RE: 03V-350

SAFETY RECALL

2002-2003 GL1800/A Frame Weld

Welding Overview

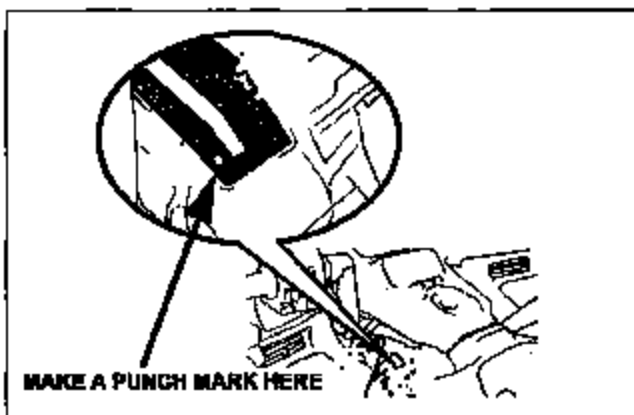
The repair procedure consists of adding additional TIG welding to the frame where the lower cross member joins the side rails.

A qualified TIG welder will weld the frame following the procedures in the *2002-2003 GL1800/A Frame Weld Safety Recall Welding Manual*.
